From: [Reynolds, Ronnie J. \(Constellation Nuclear\)](#)
To: [Richard Guzman](#)
Cc: [Rossi, Matthew: \(Constellation Nuclear\)](#)
Subject: [External_Sender] RE: Courtesy copy of Supplemental Letter for NMP1 -2 to Remove NMP3 Designation
Date: Monday, August 12, 2024 2:40:36 PM
Attachments: [Revised NMP2 Figure 4.1-1 Clean Page 8-12-24.pdf](#)
[Revised NMP1 Figure 5.1-1 Clean Page 8-12-24.pdf](#)

Please find the revised figures for the NMP LAR to remove the NMP3 designation from the Unit 1 and Unit 2 Technical Specifications. The attached figures supersede the figures provided in the Supplemental Letter dated 7/31/24.

FIGURE 5.1-1
SITE BOUNDARIES
NINE MILE POINT - UNIT 1

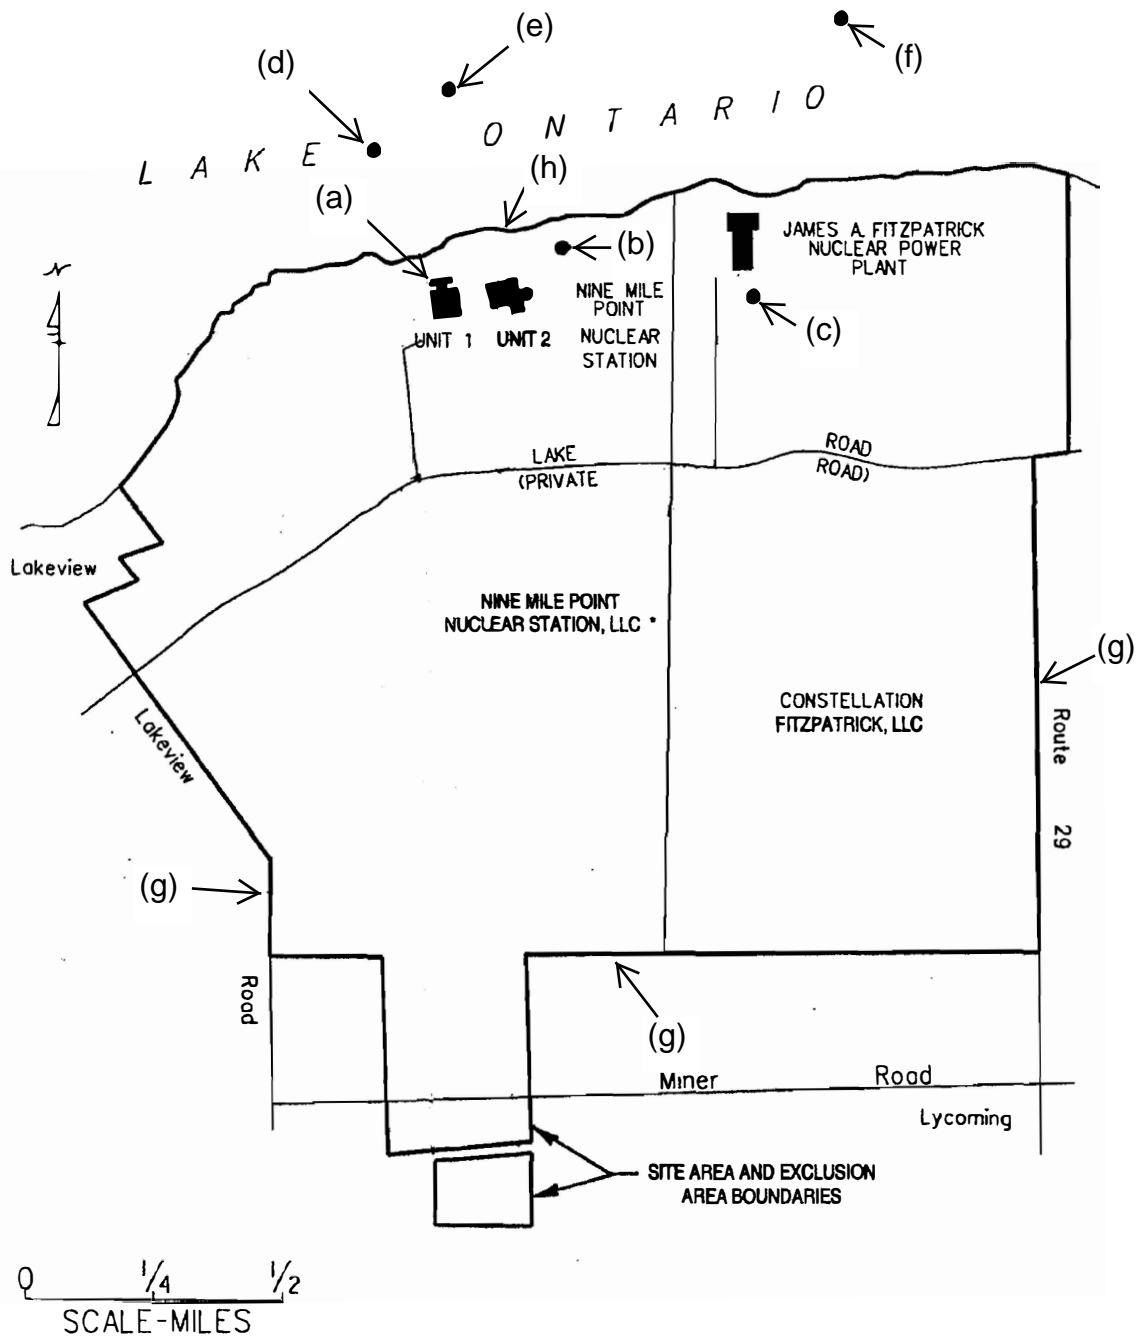
The Unit 1 Figure 5.1-1 was revised to remove the revision bar from Section 5.2.

Figure 4.1-1 (Page 1 of 1)
Site Area and Land Portion of Exclusion Area Boundaries

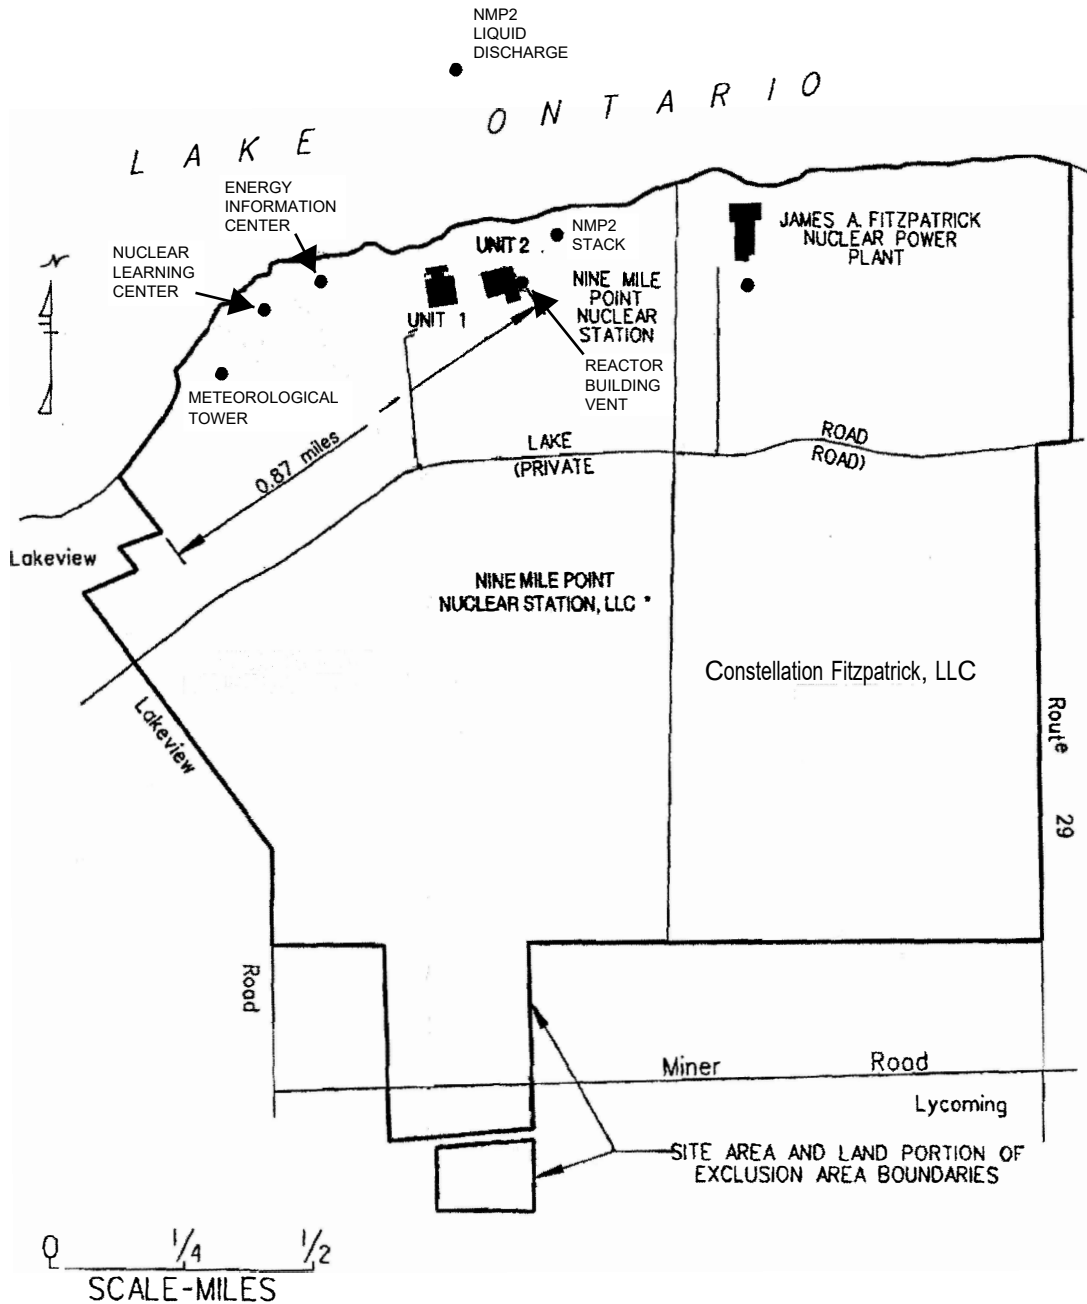
The Unit 2 Figure 4.1-1 was revised to include the structure designations for:

- NMP2 Liquid Discharge
- Energy Information Center
- Nuclear Learning Center
- Meteorological Tower
- NMP2 Stack
- Reactor Building Vent
